Application for Licence Amendment

Licence Number	L7465/1999/9
Licence Holder	Northern Star (Carosue Dam) Pty Ltd
ACN	116 649 122
File Number	APP-0026528
Premises	Carosue Dam Minesite Legal description – Mining tenements M28/269, M31/220, and M31/295 As defined by the premises maps attached to the Revised Licence
Date of Report	15 April 2025
Decision	Revised licence granted

Figure 1: TSF Cell 4 infrastructure

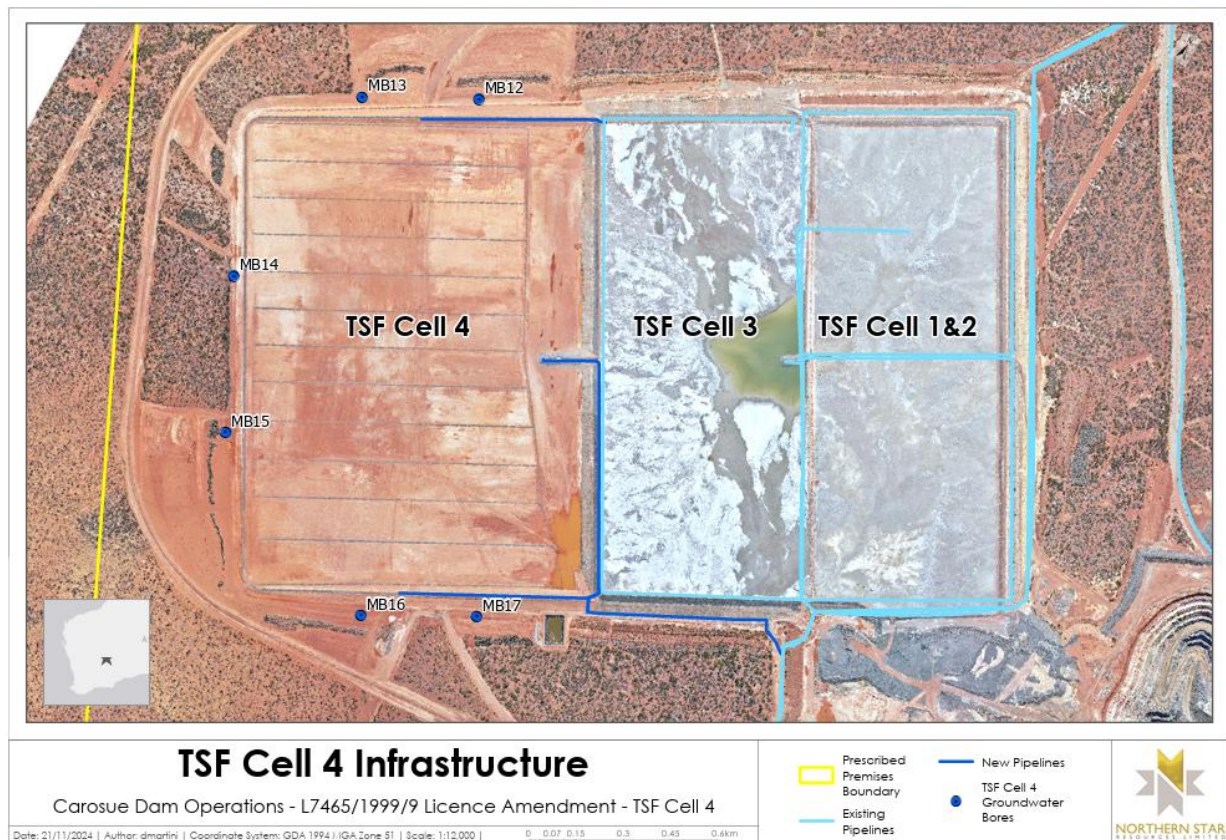
Carosue Dam Operations (CDO) TSF Cell 4 forms part of the broader CDO Paddock TSF which manages all tailings generated from the CDO processing plant. TSF Cell 4 is located on the western side of Cell 3 and operates as a standalone facility (Figure 1). The starter embankment is the first stage of operating TSF Cell 4 before several raises associated with future works approval applications.

Six groundwater monitoring bores were installed around the perimeter of TSF Cell 4 to monitor groundwater conditions in accordance with Condition 3 of works approval W6626/2021/1. An Environmental Compliance Report (ECR) was submitted by Northern Star to DWER on 21 February 2024 demonstrating compliance against applicable construction requirements. The locations of the new groundwater monitoring wells are shown in Figure 1.

Figure 3: Vibrating Wire Piezometers (VWP) installation locations

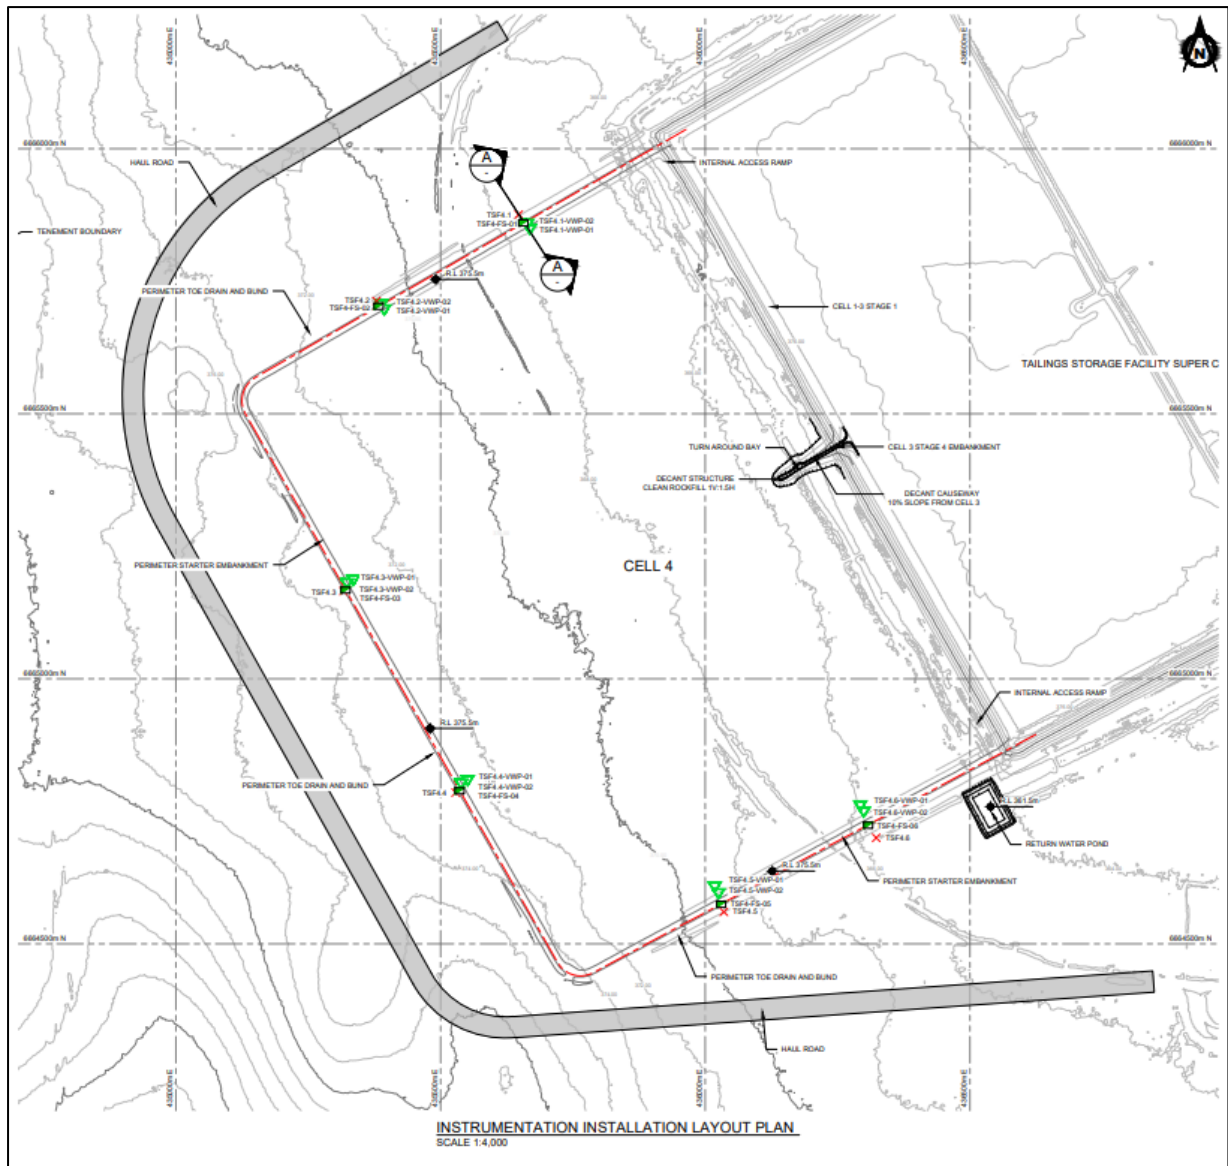
Six pairs of vibrating wire piezometers (VWP) were supplied, installed and configured by Tetra Tech at TSF Cell 4 (Figure 3).

One vibrating wire piezometer (VWP) per pair is mounted on a steel post just above the cleared natural ground surface immediately upstream of the starter embankment to measure pore pressure within emplaced tailings once tailings deposition reaches and covers the sensor.

The second VWP per pair is installed in a shallow trench into the starter embankment construction fill, just above the interface between cleared natural ground and the embankment fill to measure the pore pressure in the base of the starter embankment fill, just downstream of the cut-off trench.
